DuraVent Product Bulletin

NEW PolyPro Locking System Update

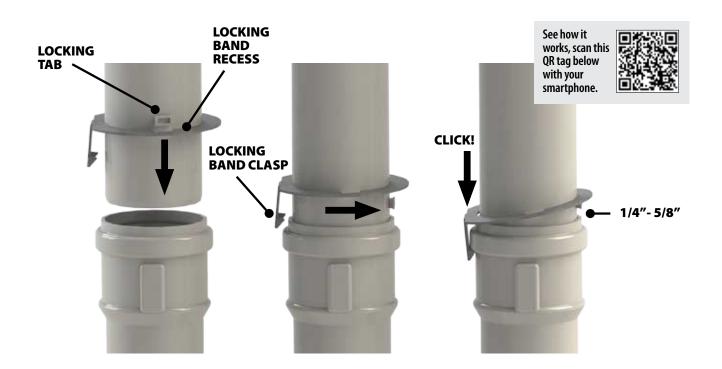
Effective November 1, 2014, M&G DuraVent's PolyPro high-efficiency appliance (category IV) venting product will have a new and improved locking system. This new locking system incorporates a locking tab on the male end of the pipe and a revised locking band that slides over the tab, twists and firmly grasps the socket of the next pipe. This approach offers installers a number of important advantages including a secure mechanical connection (rather than relying on friction alone) and the ability to inspect the joint after installation for proper insertion depth.

The locking band will now be placed on the pipe, elbows and tees at the factory. There will be new pricing for these parts that will include the addition of the locking band. Including the locking band(s) with the part will ensure the requirement for the listing is met. There is no need to remember to include separate locking bands on your order as before. All new parts with the upgraded locking system will have a new part number ending in "L".

New PolyPro Installation Instructions are available on the website. The installation for this new style remains very similar to the original style. As before, insert the pipe fitting until it bottoms out on the female pipe socket (the locking tab will now hit the socket). Disengage the male end of the pipe $\frac{14''-5}{8''}$ to allow for pipe expansion. If the locking tab is farther than $\frac{5}{8''}$ from the edge of the socket, the pipe is not fully engaged and the locking band will not be able to lock on to the pipe. If the installation requires that the tab end of the pipe be cut off, then an alternate locking clamp (i.e. PAC or LBC clamp) will be needed instead of the standard locking band. For certain parts where a locking tab cannot be applied at the factory (adjustable pipe, increasers, etc), these parts will now include a PAC clamp.
